Project Number: 56-3016-24

Project Name: HPWO - New Carlisle Community Health Center

This Addendum provides modifications and clarifications To the Bid Documents dated **Friday, June 26, 2026** Bidder shall ascertain prior to submitting its Bid Form that it has received all Addenda issued and shall acknowledge receipt of each Addendum on the Bid Form.

ADDENDUM NO. 003

SHEET
E201

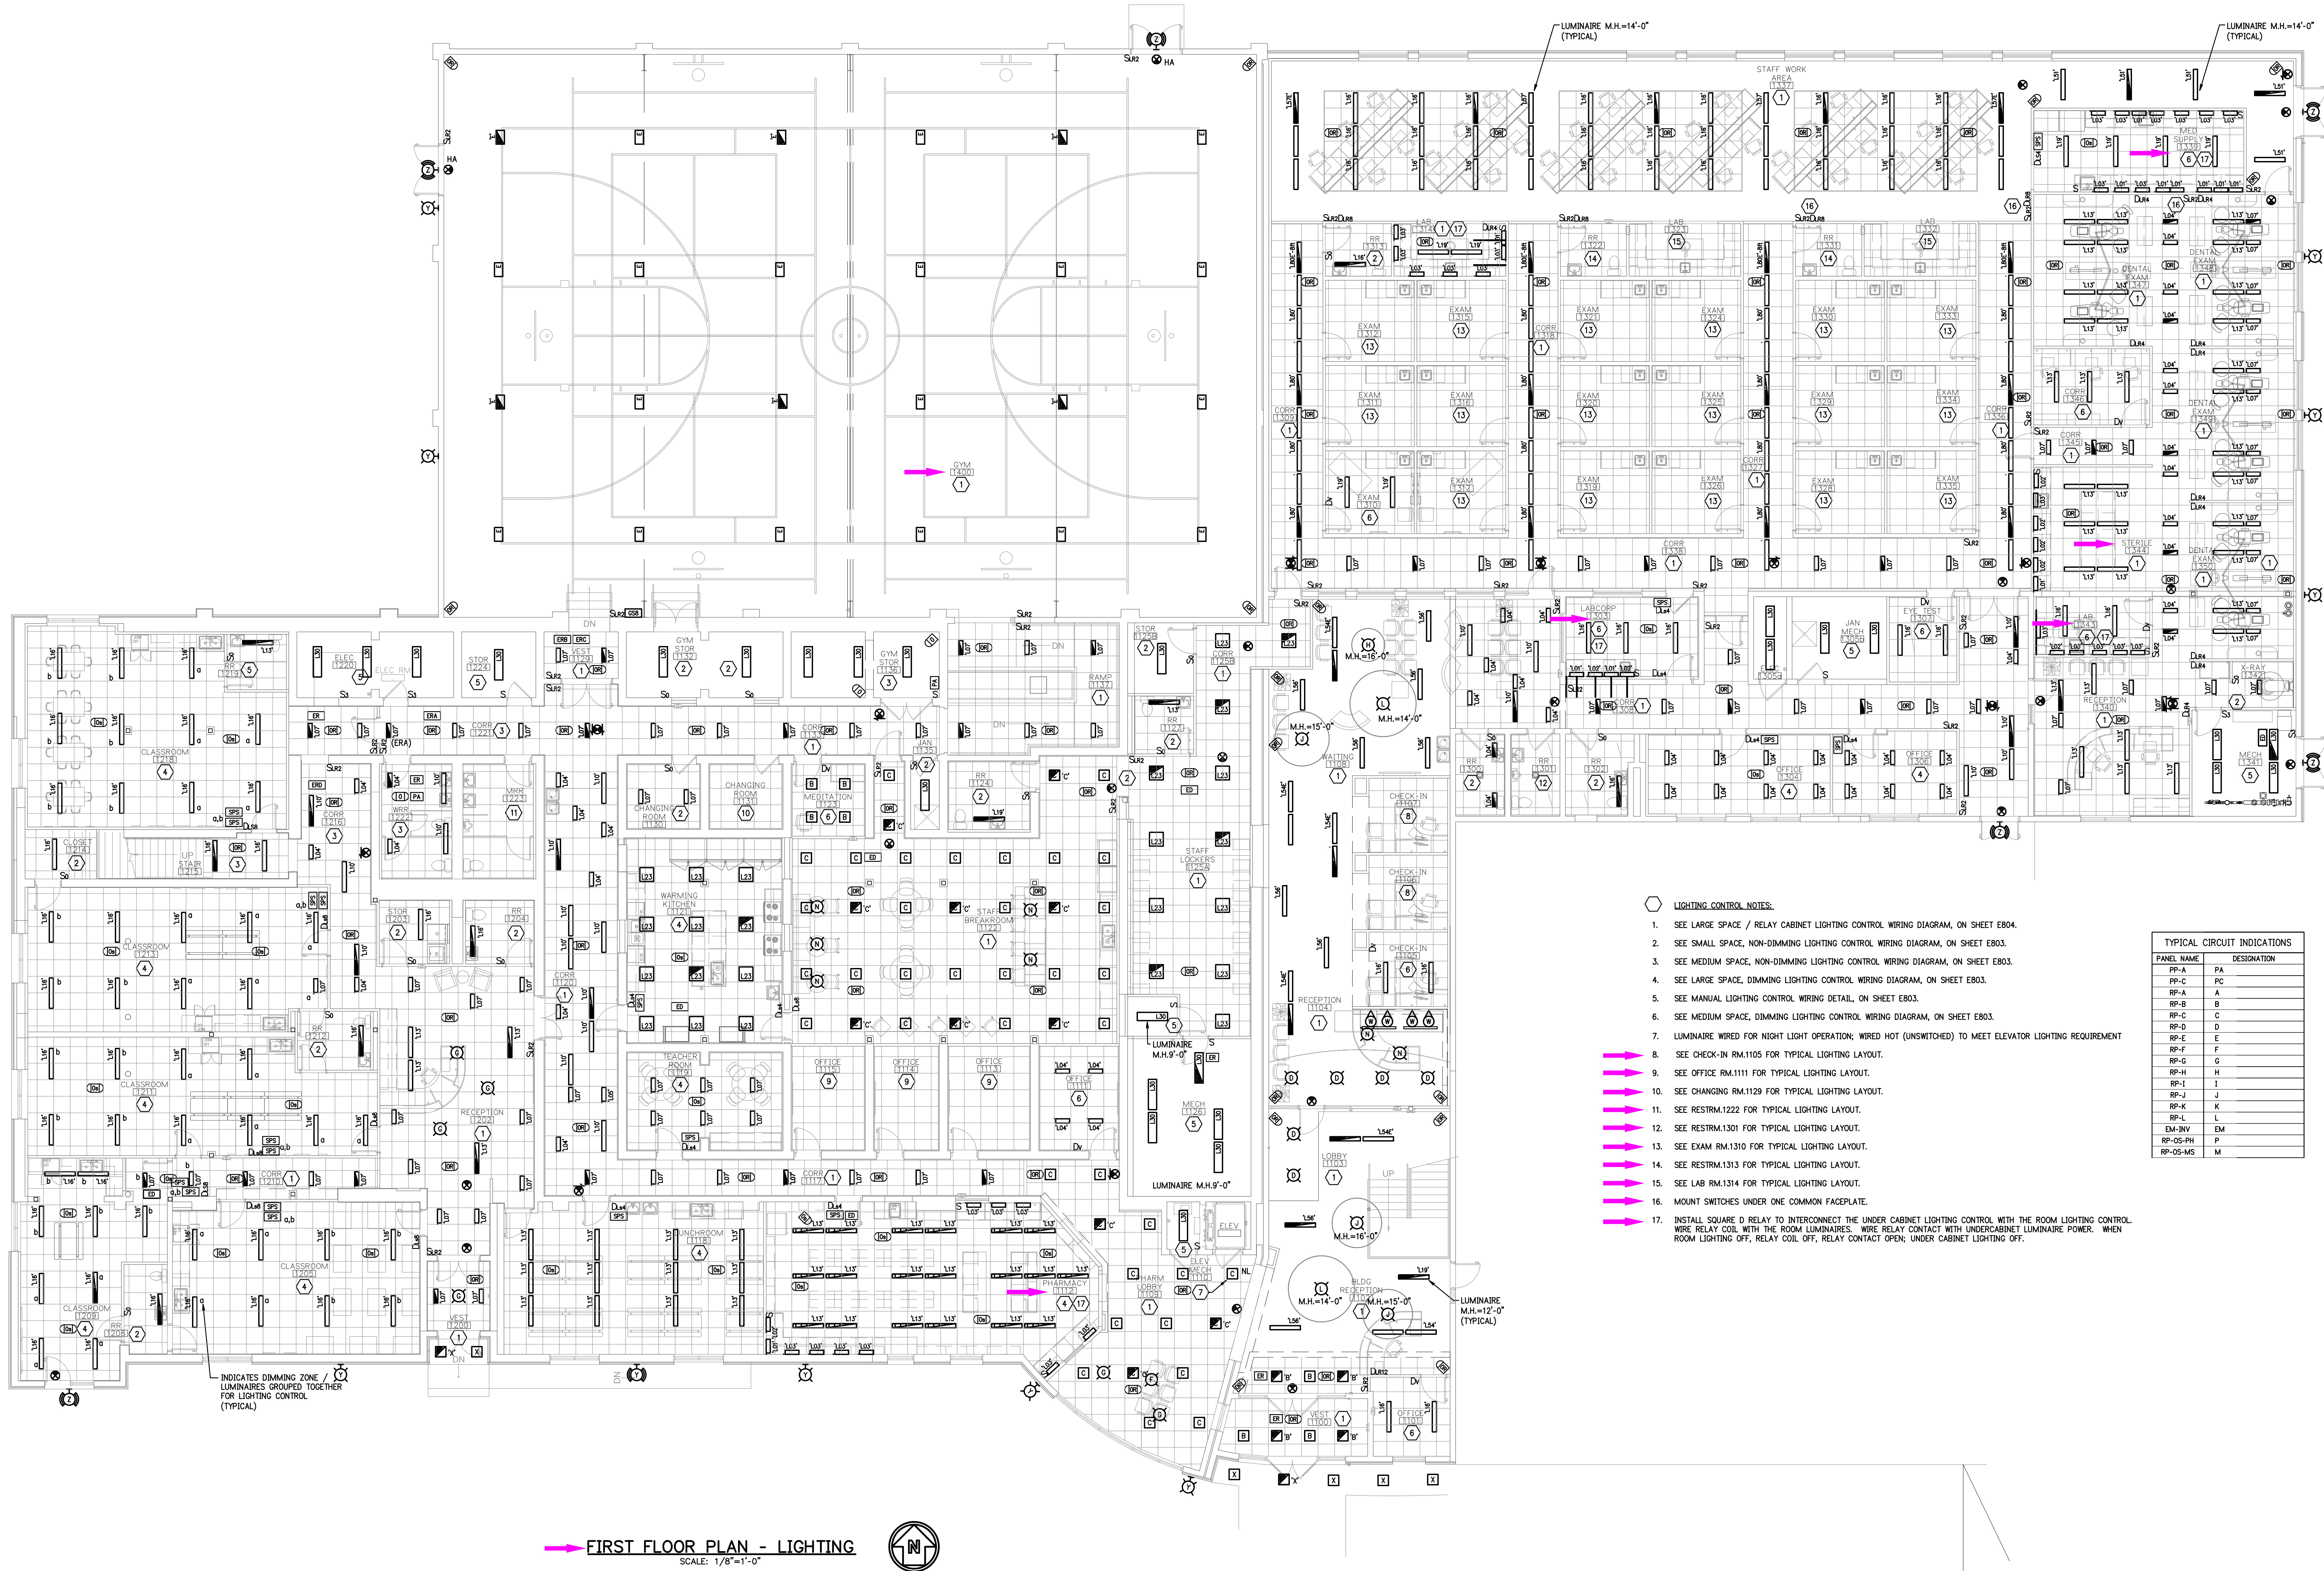
B. Drawing E201 – First Floor Plan – Lighting (Drawing Reissued):

1. Pharmacy Room 1112, Lab Room 1303, Room 1343, Supply Room 1339, Sterile Room 1344 - Added lighting.
2. Gym Room 1400 - Changed type G to E.
3. Added lighting control devices (dimming Switches, controllers, power supplies, and occupancy sensors).
4. Added floor plan notes.

ENLARGED UNIT 3 - DENTAL SUITE - FLOOR PLAN - ELECTRICAL
SCALE: 1/4"=1'-0"

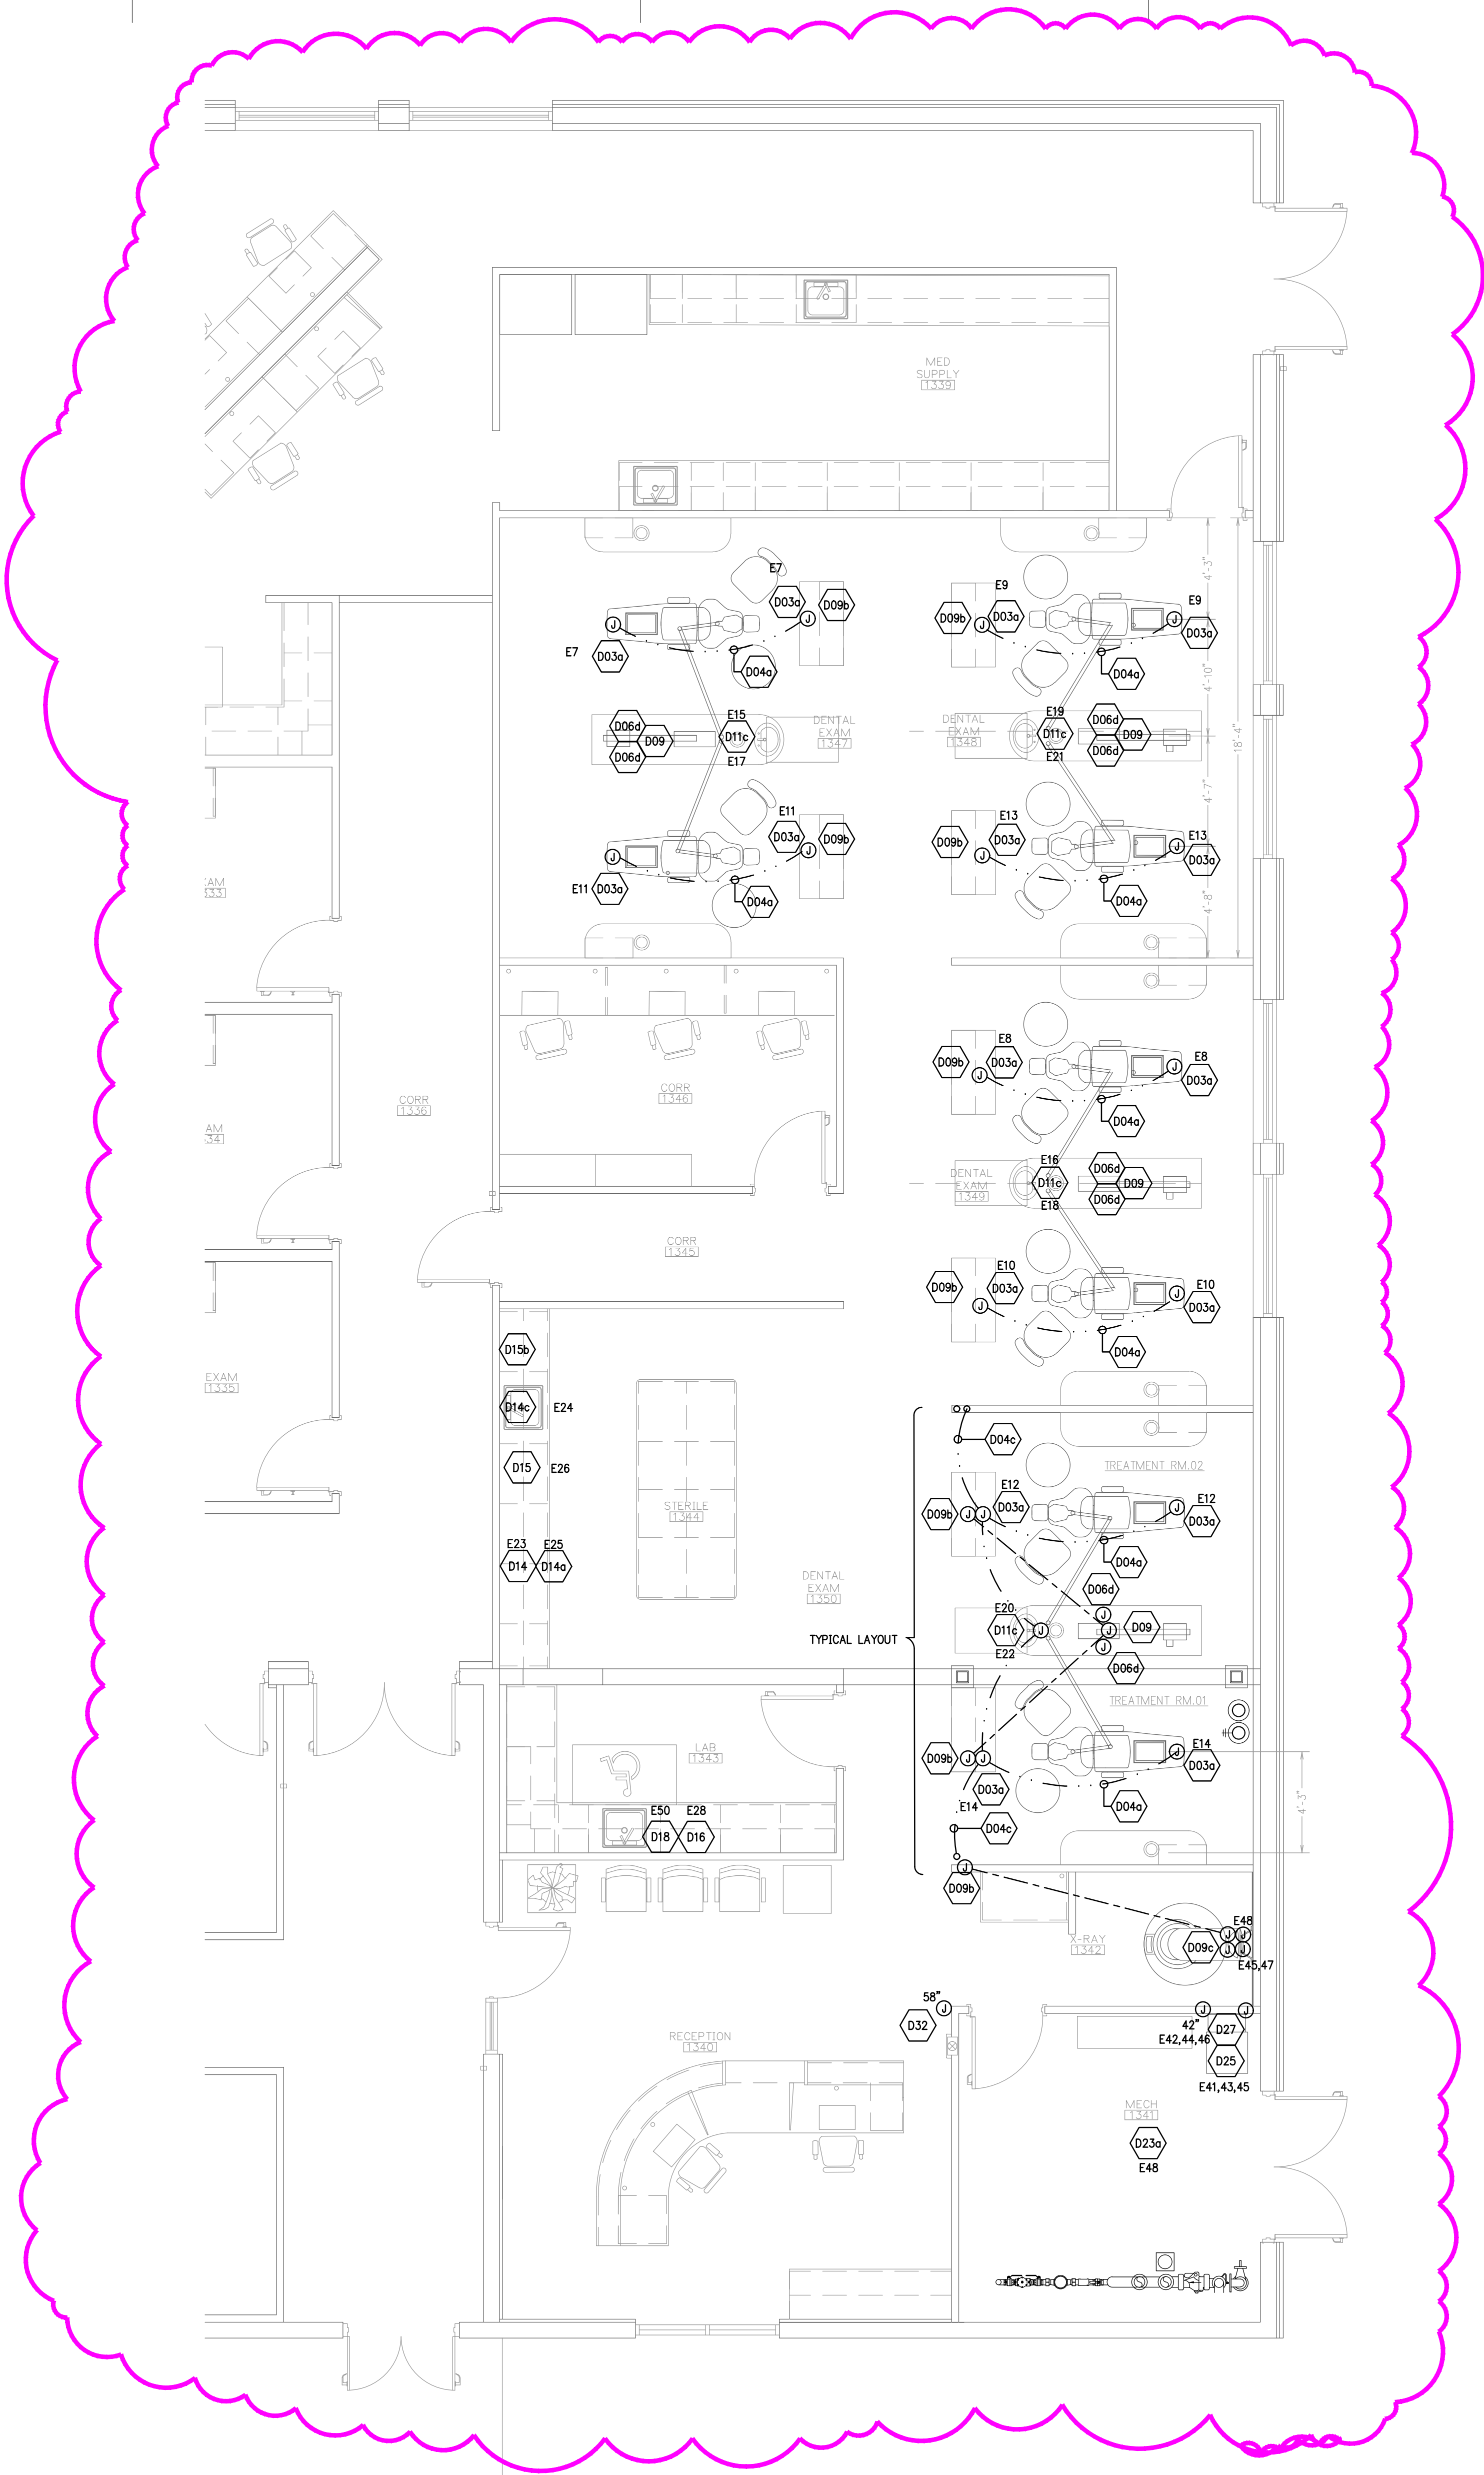
1. Added general note 3: "ALL BRANCH CIRCUITS SERVING RECEPTACLES AND FIXED ELECTRICAL EQUIPMENT IN THE PATIENT CARE AREA SHALL COMPLY WITH NEC 517.13. PROVIDE METAL RACEWAY AND AN INSULATED COPPER EQUIPMENT GROUNDING CONDUCTOR TO ESTABLISH THE REQUIRED REDUNDANT EQUIPMENT GROUNDING PATH."

- COORDINATE THE LOCATION OF ALL DATA OUTLETS WITH THE OWNER AND THE OWNER'S DENTAL EQUIPMENT SUPPLIER.
- ALL BRANCH CIRCUITS SERVING RECEPTACLES AND FIXED ELECTRICAL EQUIPMENT IN THE PATIENT CARE AREA SHALL COMPLY WITH NEC 517.13. PROVIDE METAL RACEWAY AND AN INSULATED COPPER EQUIPMENT GROUNDING CONDUCTOR TO ESTABLISH THE REQUIRED REDUNDANT EQUIPMENT GROUNDING PATH.
